#### **AGENDA**

#### PLANNING AND ZONING COMMISSION WORK SESSION City Hall, 385 South Goliad, Rockwall, Texas Council Chambers December 30, 2019 6:00 P.M.

P2019-048: Rockwall Commercial Addition Addition

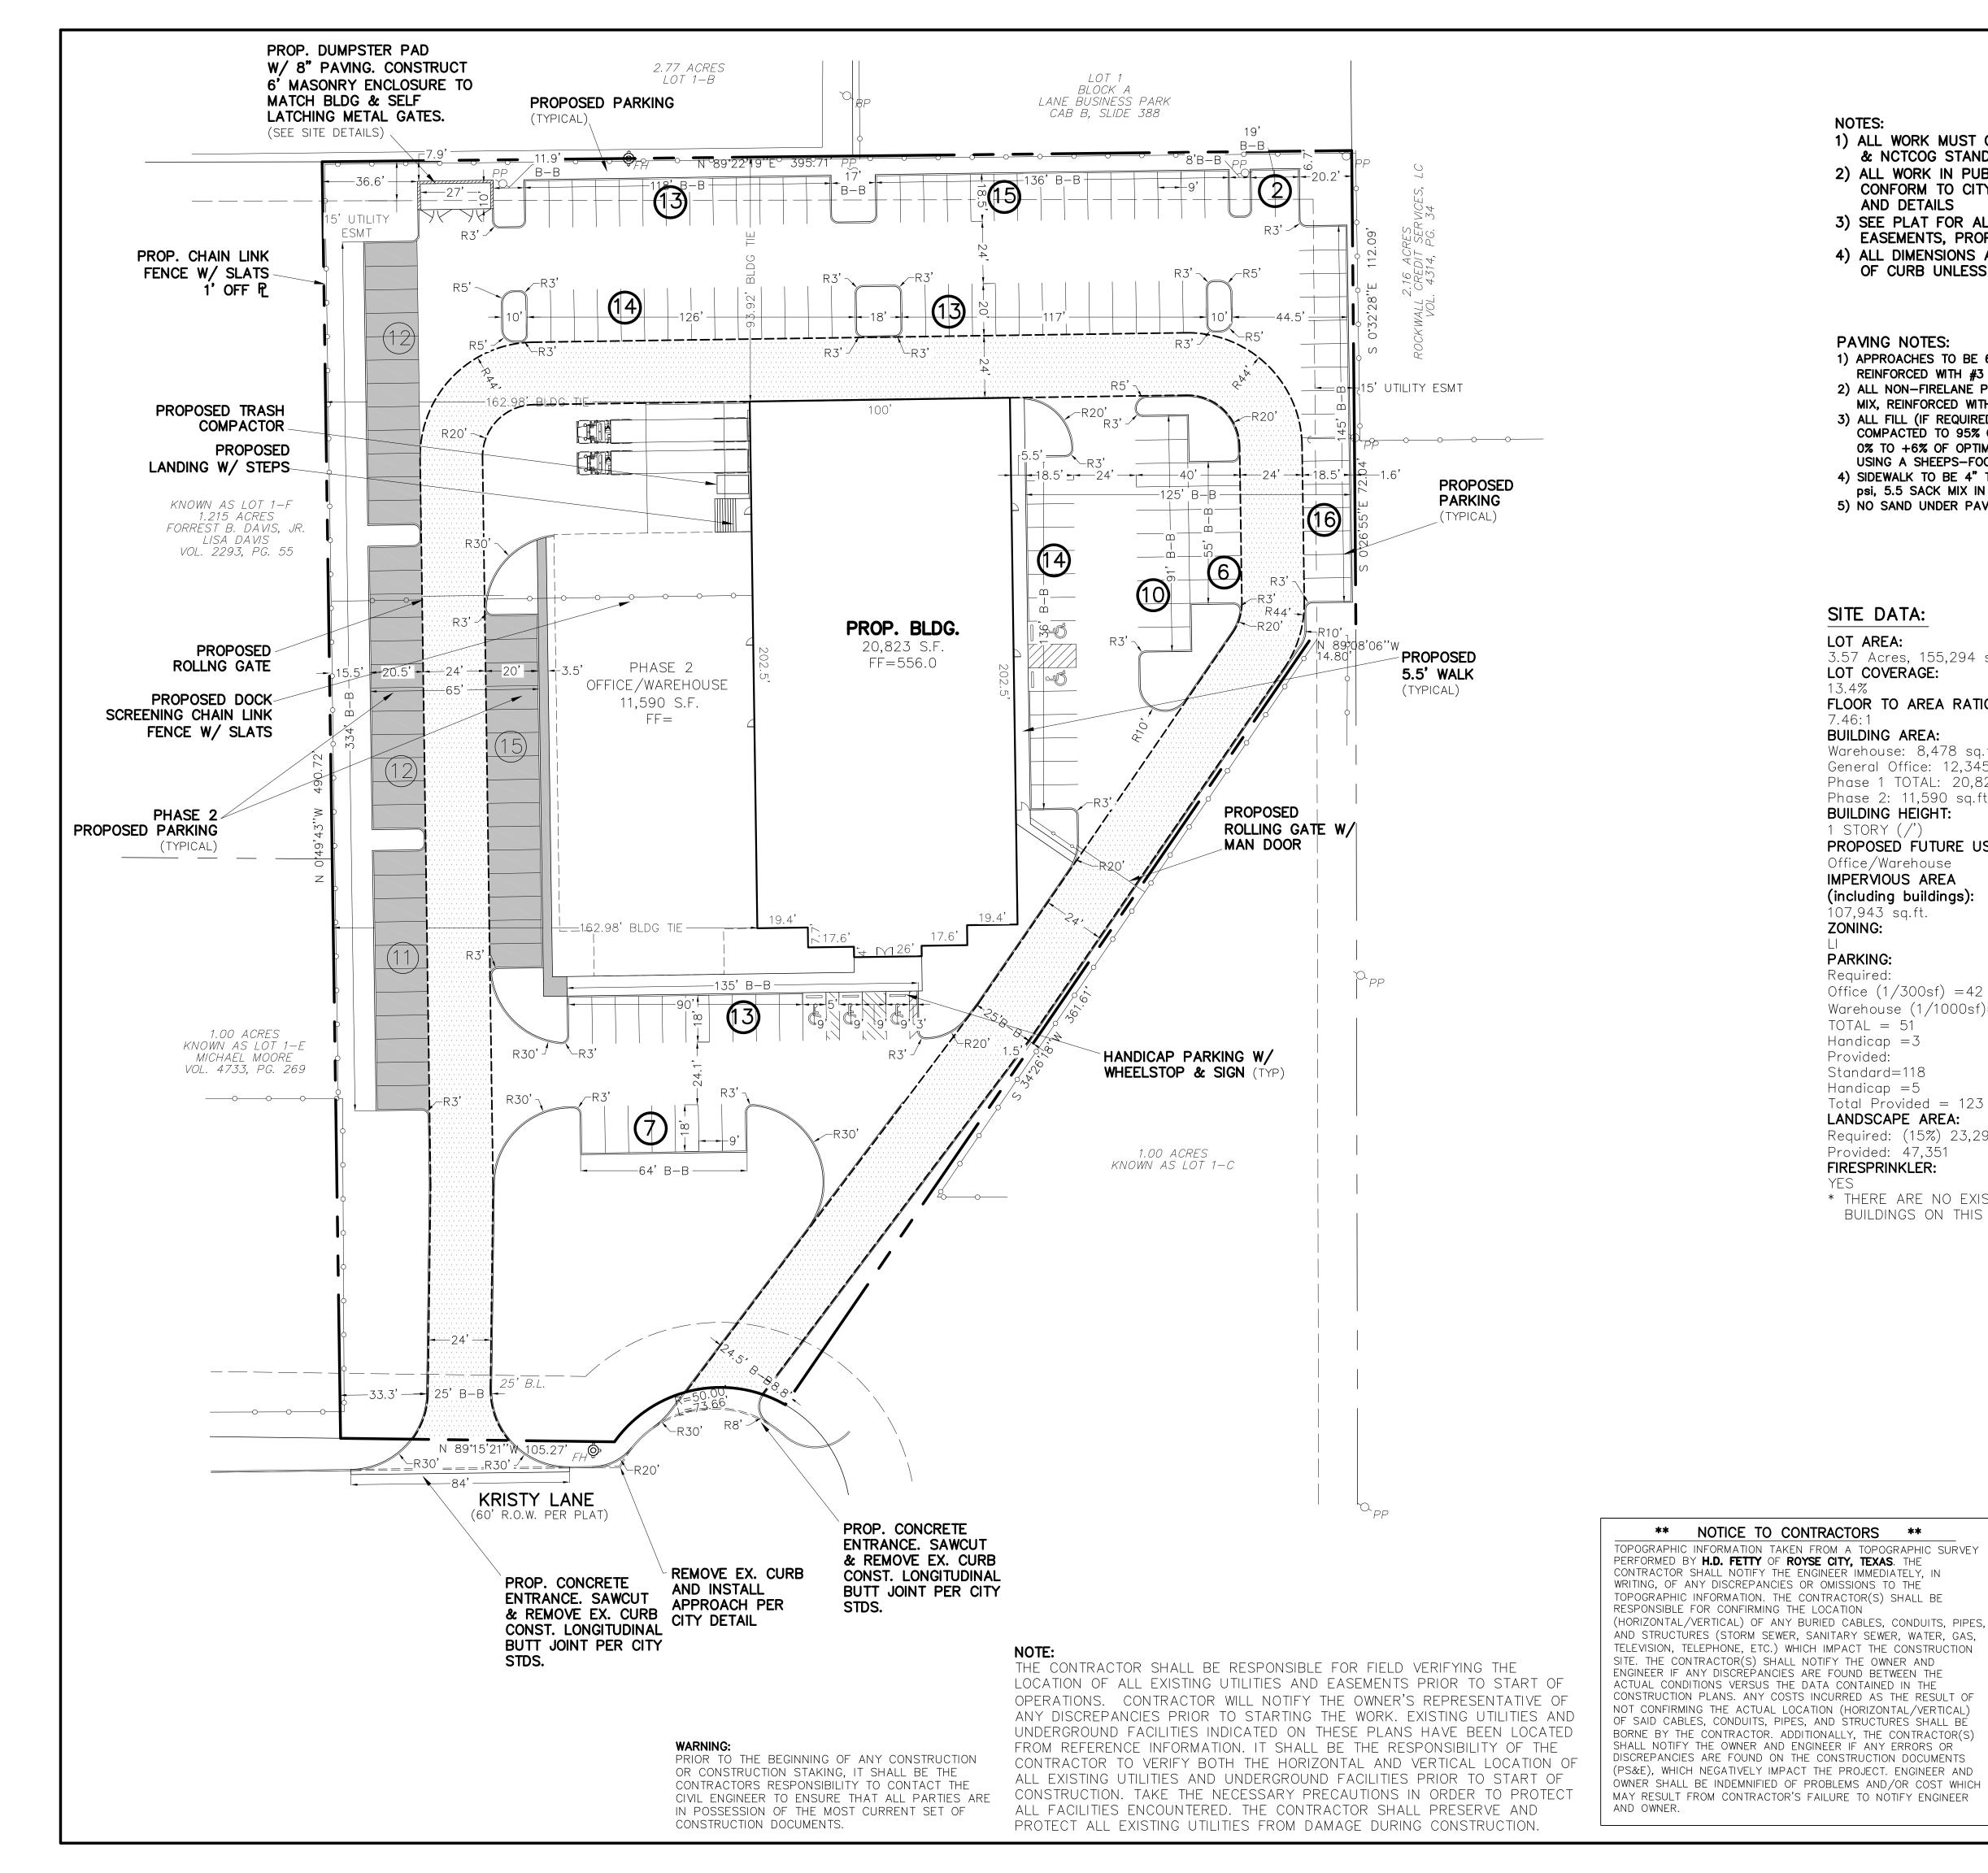
M.7 Landscape Plan. Please make the following clarifications and changes to thelandscape plan to ensure staff can properly review this project and convey all of the required elements to the City's boards and commissions (Sec. 2, Art. VIII, UDC):

- 1) Indicate the locations and dimensions of the required landscape buffers Minimum of 10-feet required. (Subsection. 5.01(A), Art. VIII, UDC)
- 2) Correct Planting list -- Sheet No. L2-05 -- and indicate all Large Trees to be a minimum4-inch caliper and Shrubs to be a minimum of 3 Gallon. (Sec. 4(A)(2), Art. VIII, UDC)

- 3) Proposed parking lots do not indicate shrubs for headlight screening for proposed parking lots adjacent to street rightof-ways. Provide headlight screening. (Sec. 5.02(C)(1), Art. VIII, UDC)

- 6) Provide note indicating irrigation will meet requirements of UDC Update note on Sheet No. L2.02 to include this note. (Subsection 5.04, Art. VIII, UDC)
